# UNITED STATES PATENT AND TRADEMARK OFFICE

<b>Office Action Summary</b>	<b>Application No.</b> 10/711,593	<b>Applicant(s)</b> FAIRCHILD, MARK D.	
	<b>Examiner</b> Benjamin P. Lee	<b>Art Unit</b> 3641

## **DETAILED ACTION**

*Fig. 1.**Fig. 2.**Fig. 3.****Allowable Subject Matter***

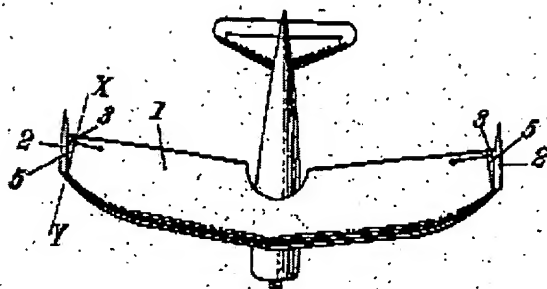
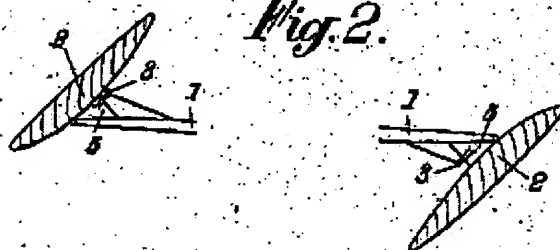
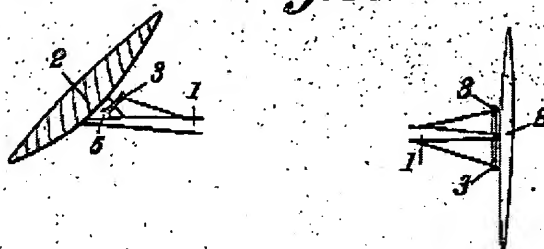
7. In regards to claim 2, Richard et al disclose that the net induced drag differential is produced by controlling the aircraft such that the induced drag experienced by the inboard wing is greater than the induced drag experienced by the outboard wing (see fig. 3 following). Note that the left (inboard) wing "end-plate" is pivoted and the right ("outboard") wing "end-plate" is in a "neutral" position. The pivoted "end-plate" induces greater drag than the "neutral" plate.

experienced by the inboard wing (col. 1, lines 18-53). Note that the neutrally positioned "end-plate" on the right ("outboard") wing spoils or blocks the wingtip vortex reducing downwash and the pivoted "end-plate" on the left ("inboard") wing allows a wingtip vortex increasing downwash.

9. In regards to claims 6 and 8, Richard et al disclose providing adaptive control surfaces as part of the inboard and outboard wings to form a variable planform to affect the induced drag of each of the inboard and outboard wings and produce the net induced drag differential to overcome adverse yaw produced by the outboard wing (see fig. 3 following). Although figure 3 is a frontal view of the plane, it is clear and inherent that the manipulation of the "end-plates" constitutes a variable planform. As previously stated, the manipulation of the "end-plates" induces the drag differential.
